*** Updated 02/18/2020**

ATTACHMENT A
MODULE 3 – PREFERRED SCHEMATIC REPORT REVIEW COMMENTS

District: City of Worcester
School: Doherty Memorial High School
Owner’s Project Manager: AECOM Tishman
Designer Firm: Lamoureux Pagano Associates
Submittal Due Date: January 2, 2020
Submittal Received Date: December 31, 2019
Review Date: December 31, 2019 – January 24, 2020
Reviewed by: C. Forde and J. Jumpe

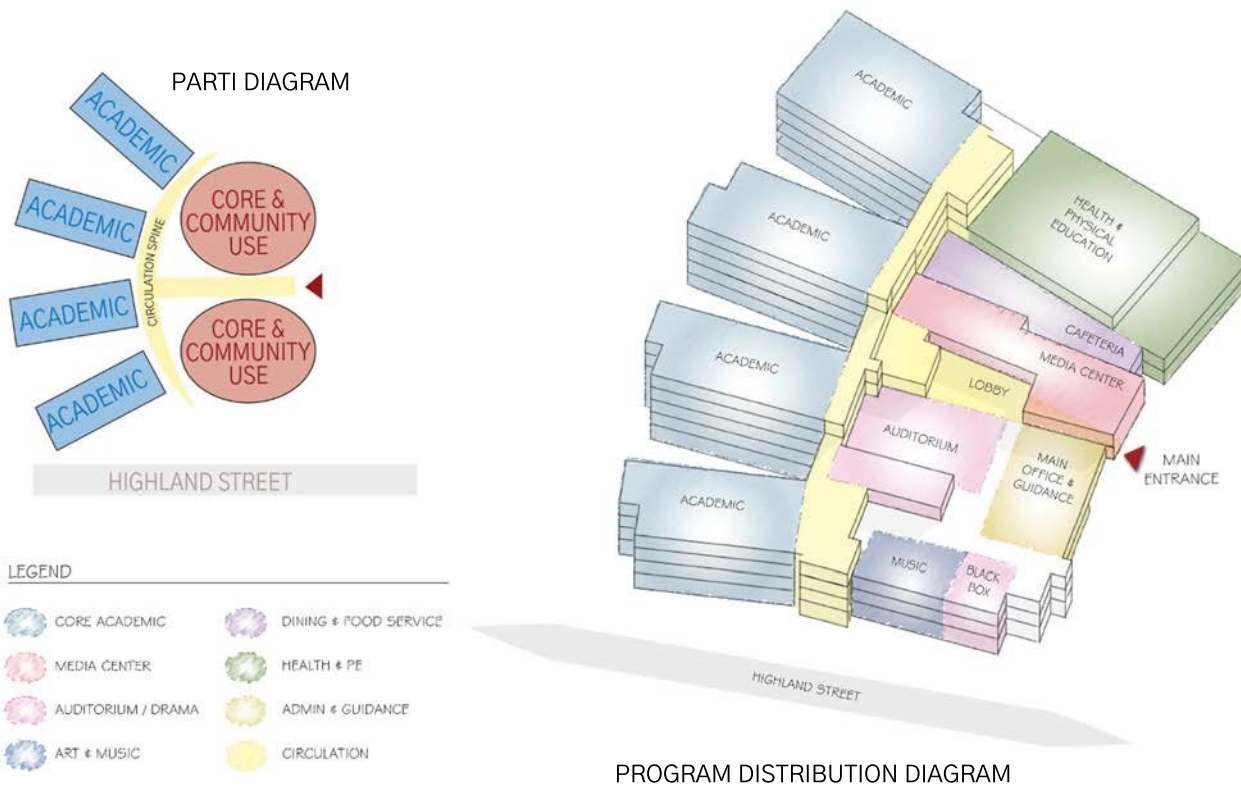
- *Describe how students will circulate through the building and confirm that the design and location of the elevators is adequate to meet the needs of the students.*

LPA|A Response: Refer to the attached “Building Circulation Diagram”. The elevators are strategically located to provide equitable access to all levels of the school, and will be sized accordingly in the Schematic Design Phase.
